Re: Titanium Metals Corporation
Henderson, Nevada Facility
NDEP Facility ID # 000537
Proposed Design Changes for First Water-Bearing Zone Groundwater Remediation Program and Response to NDEP Comments Dated September 18, 2013

TIMET Response to NDEP Comments dated September 18, 2013

BARRIER WALL OVERVIEW AND EXTRACTION WELL LOCATION PLAN

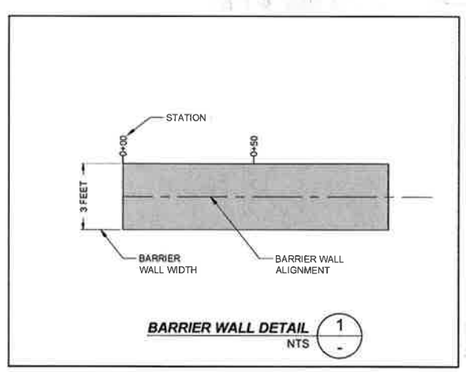
b. **NDEP requests that an additional extraction well (EWQal-01) be added to the northwest of extraction well EWQal-02. NDEP and TIMET can discuss how this well might operate in guaranteeing the contaminant plume is fully contained.**

b. TIMET agrees. The additional extraction well (EWQal-01) has been added to Drawing 01.
c. Based on the RAS (Appendix B) groundwater flow and chemical transport in the MCf is not likely to be significant. The upward flow induced by the proposed Qal/xMCf groundwater extraction system will reduce whatever migration does occur.

BARRIER WALL PROFILE
STA 0+00 TO STA 12+50

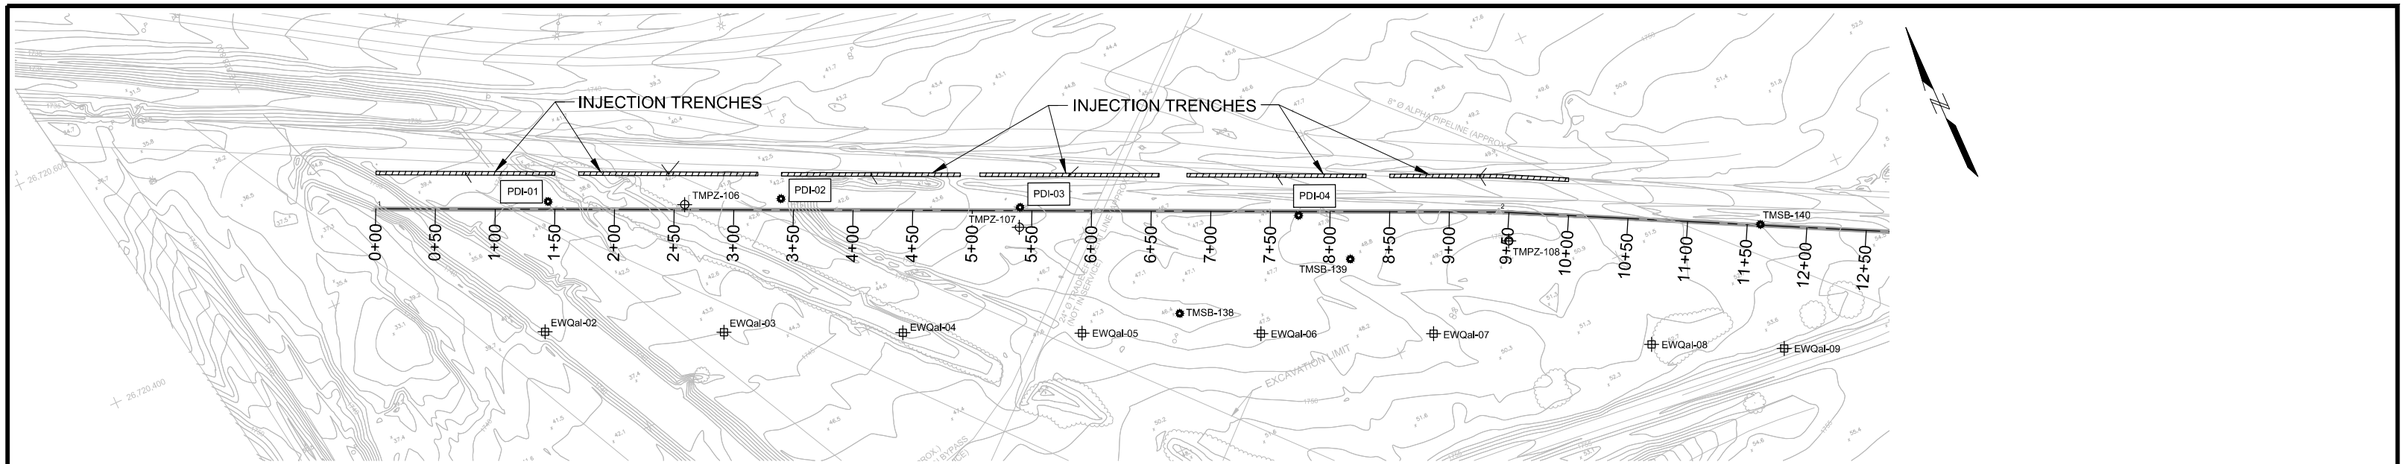
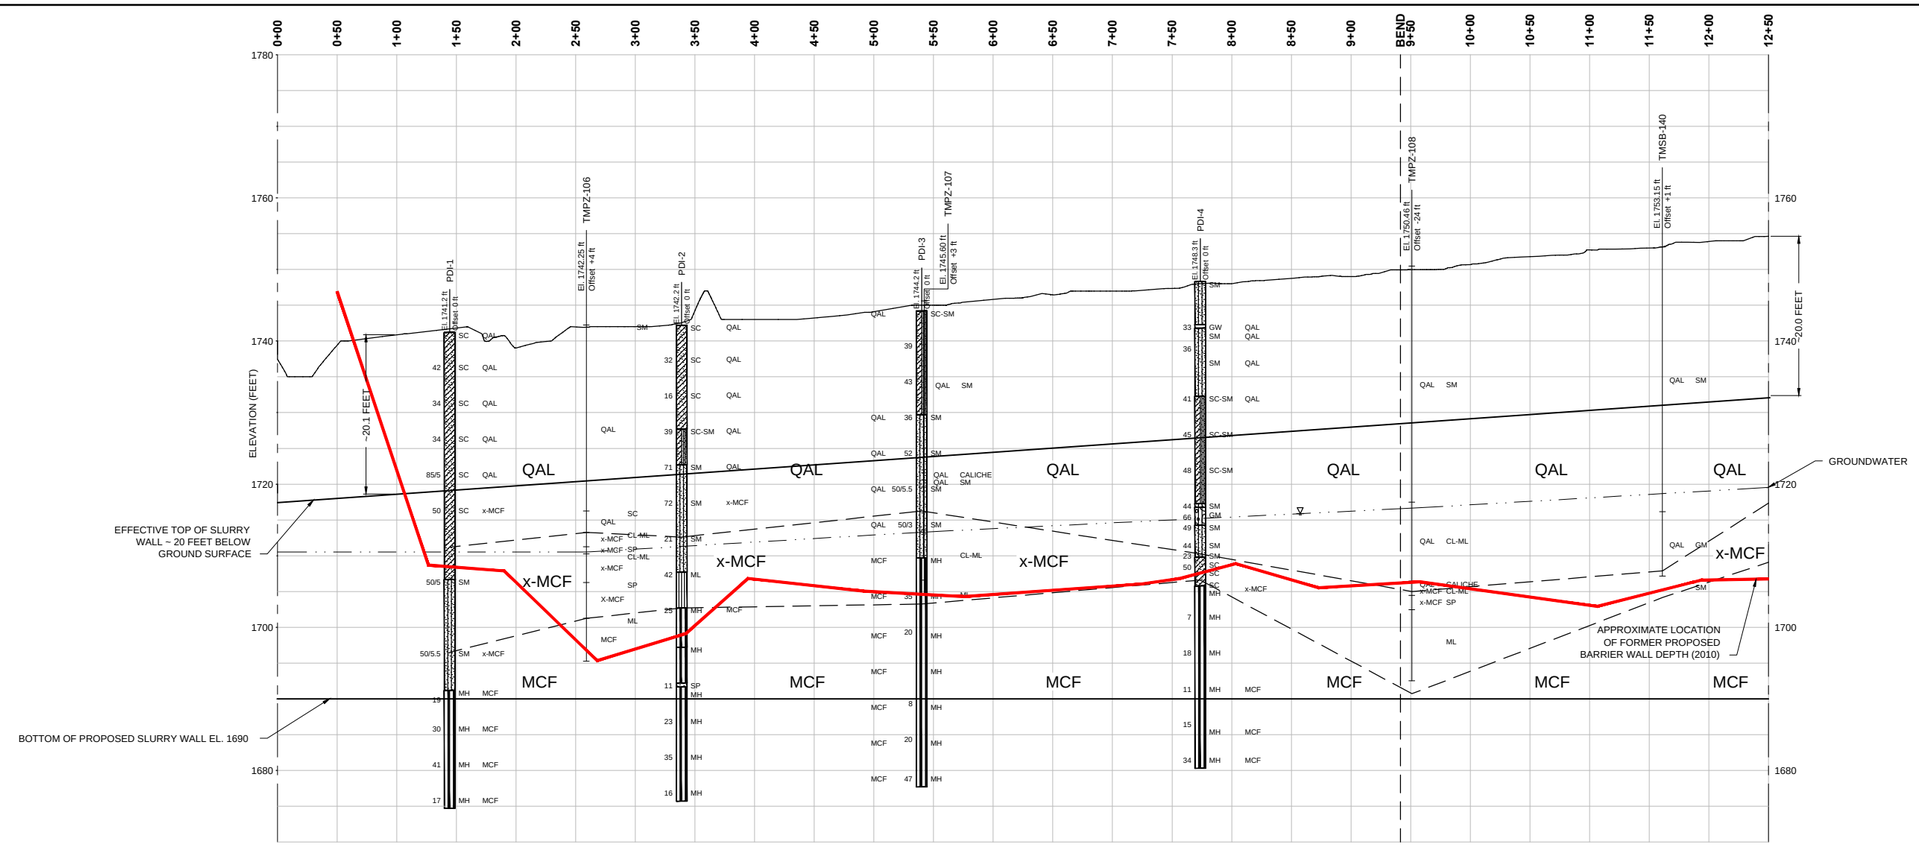
<u>NDEP Comment 4:</u> Modification 2: Barrier Wall Profile, page 2, it would be helpful to show the previous slurry wall depth on the referenced figures to fully understand and support TIMET's statements. No information has been provided to date that supports TIMET's statements that this redesign will increase the magnitude of the vertical gradients from the Upper Muddy Creek formation (UMCf) to the Quaternary alluvium (Qal). One of the reasons that pumping within the transition Muddy Creek formation (xMCf) was part of the original design was due to the presence of contaminants and the very limited upward gradients that could be induced by the Qal pumping. Please explain how this modification is consistent with the ROD and the RAS.

TIMET Response: The referenced figures have been revised to show the previous slurry wall depth.
